FINAL DRAINAGE REPORT
for
SETTLERS VIEW SUBDIVISION

July 31, 2018

JPS Project No. 111603
PCD File No.: SF-18-00_

SF-18-041

MAP NUMBER
08041C0325 F
EFFECTIVE DATE:
MARCH 17, 1997

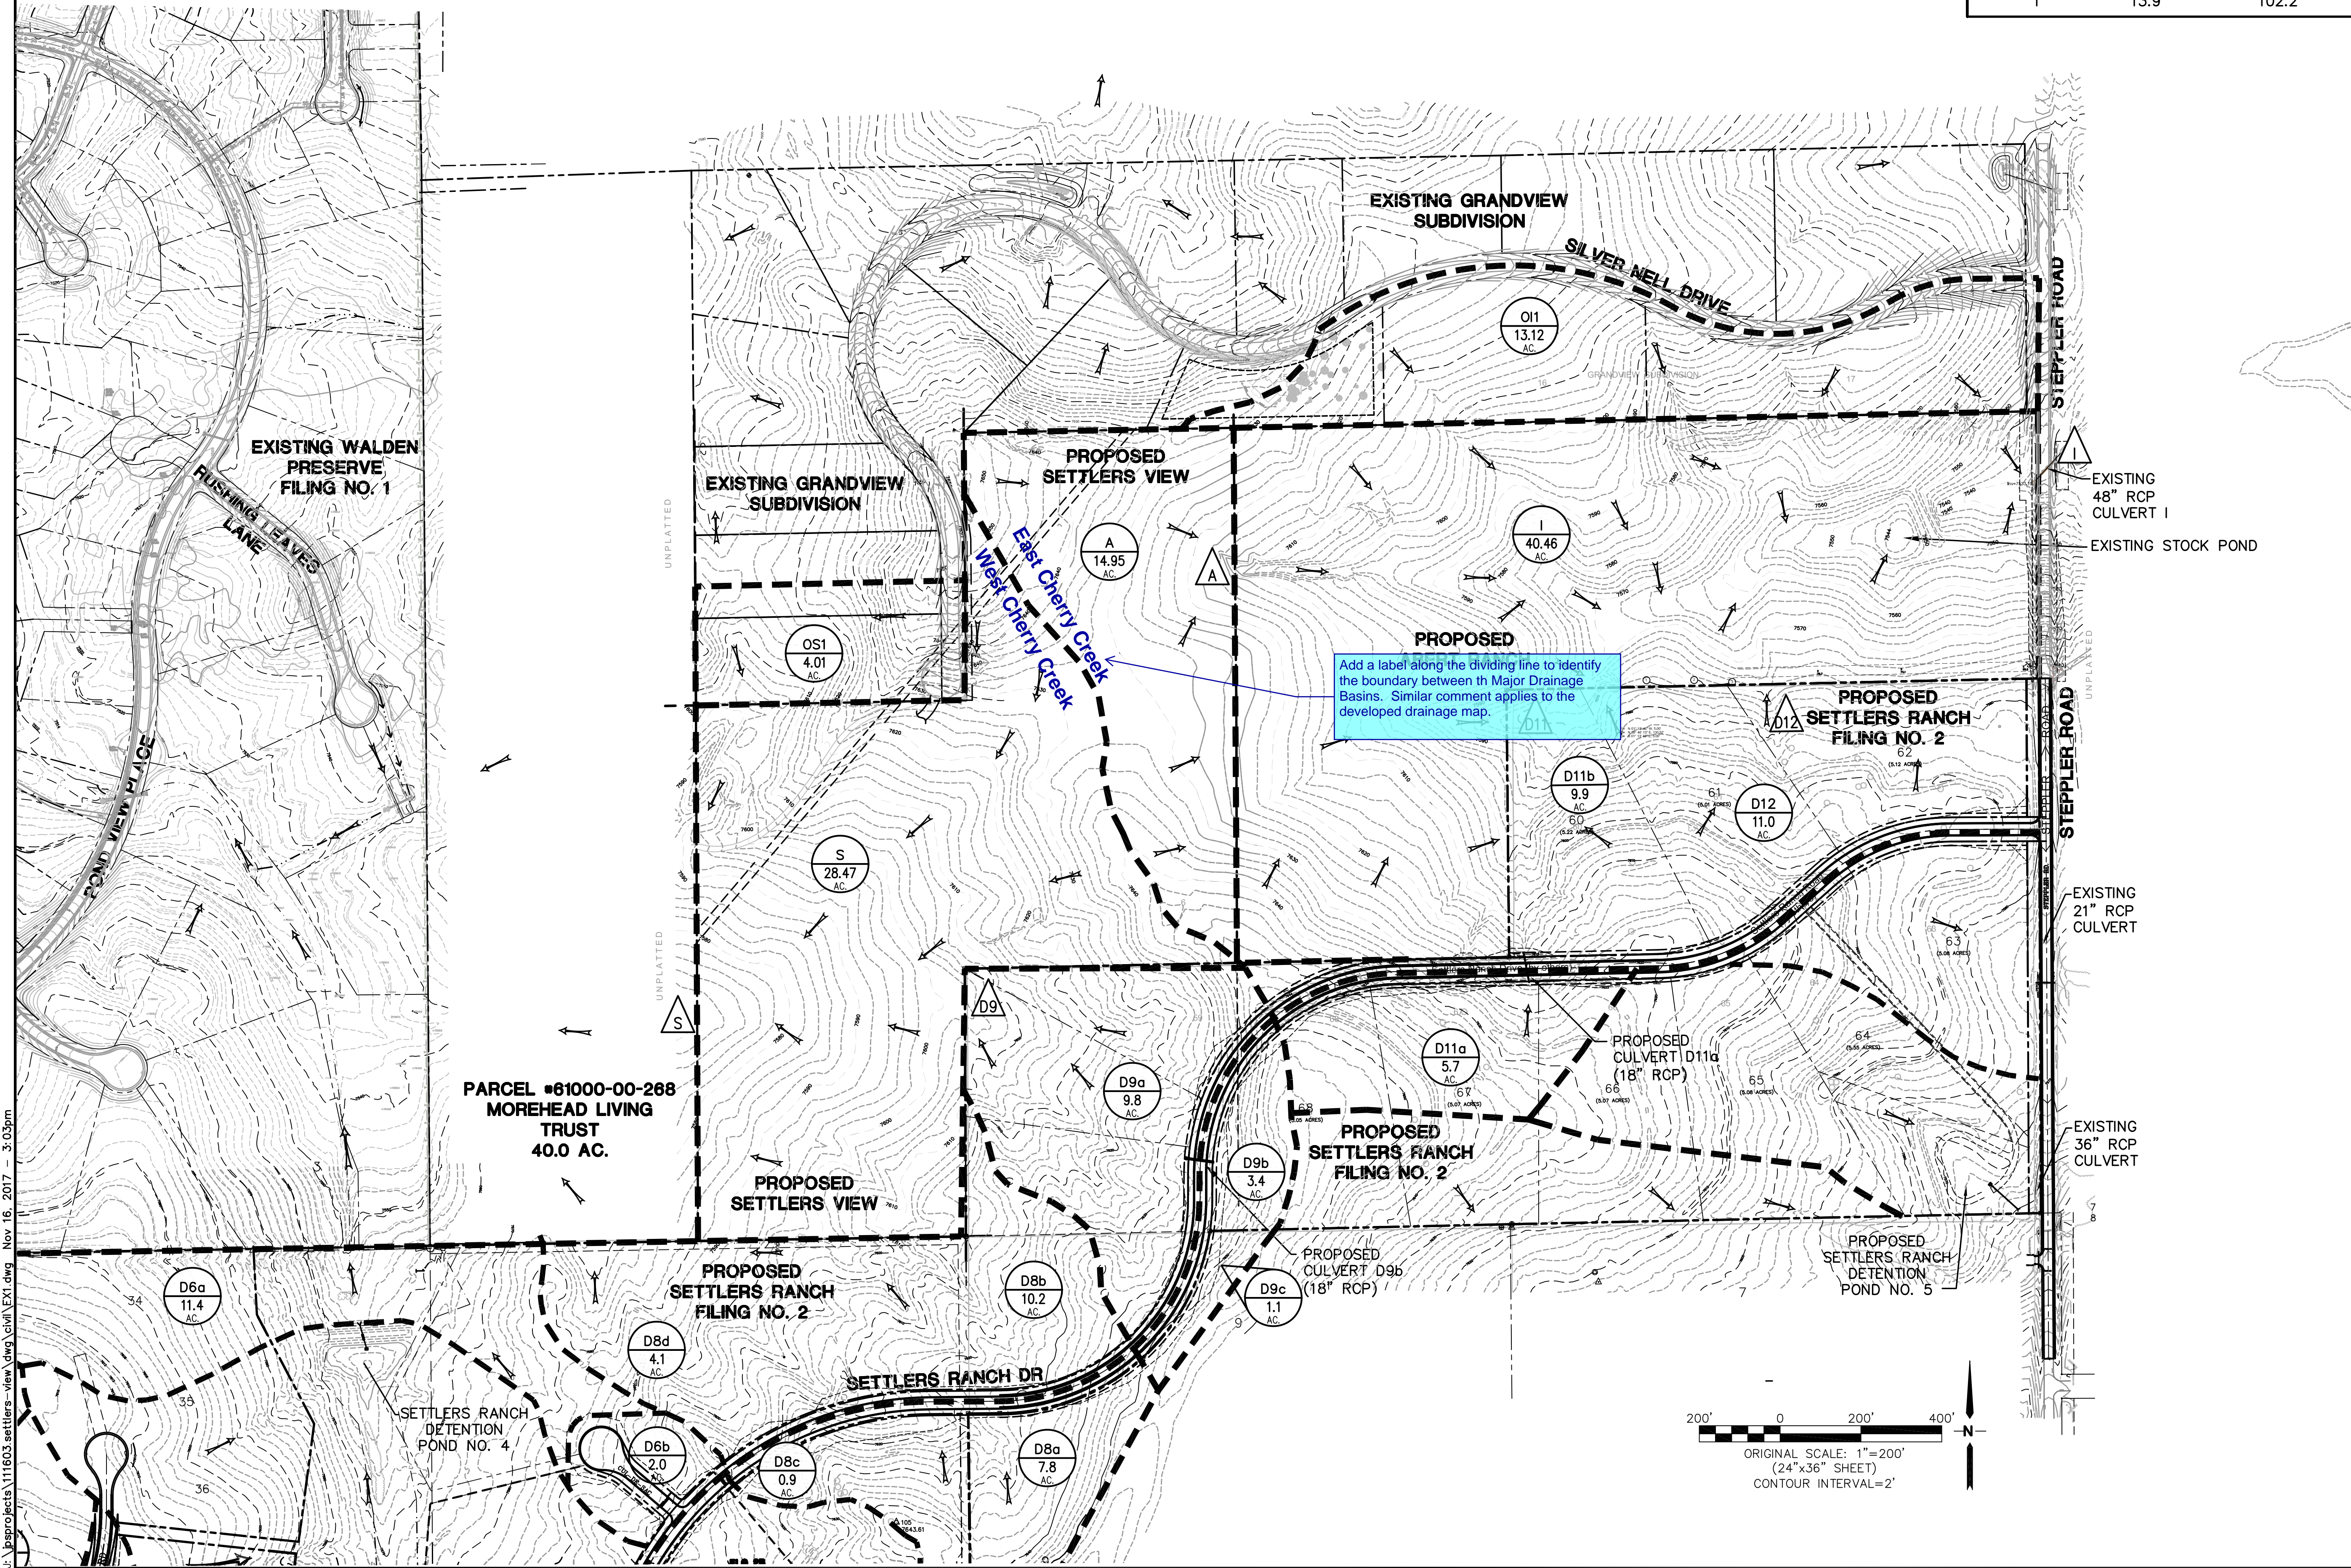
Revise to the latest FIRM 08041C0305G effective 12/7/2018 and update the Firmette.

SHEET: EX1

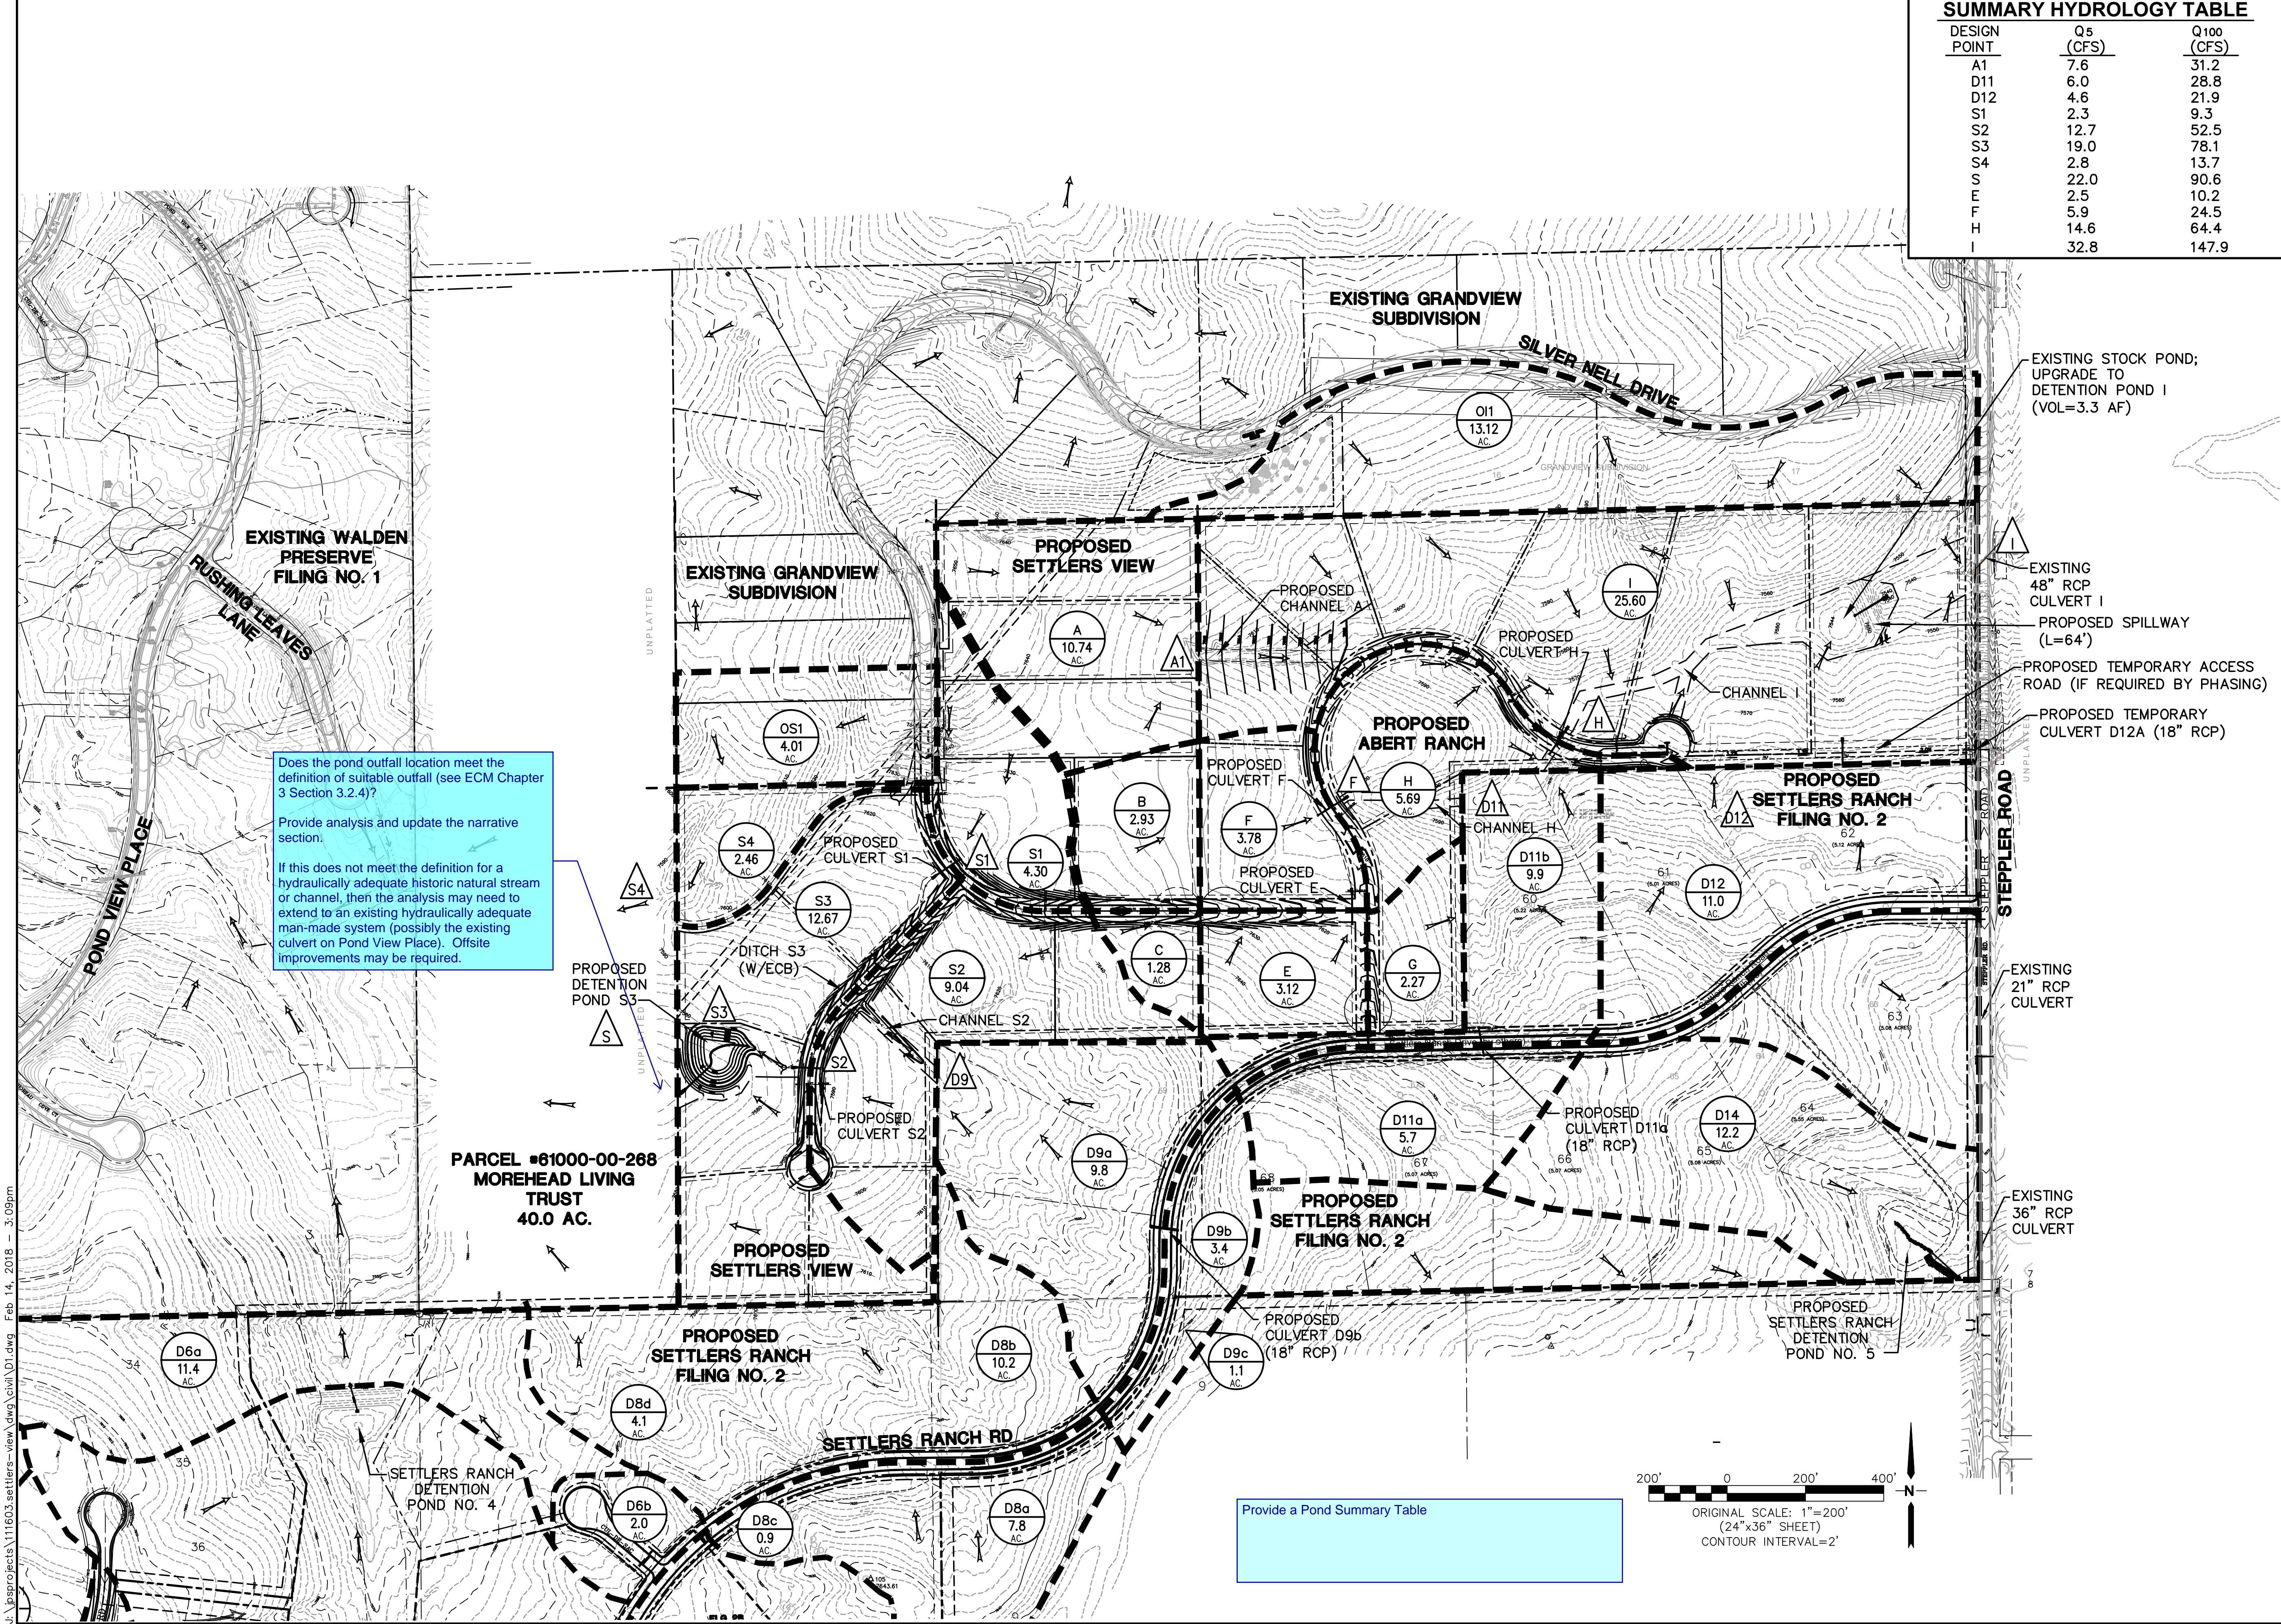
Add a label along the dividing line to identify the boundary between the Major Drainage Basins. Similar comment applies to the developed drainage map.
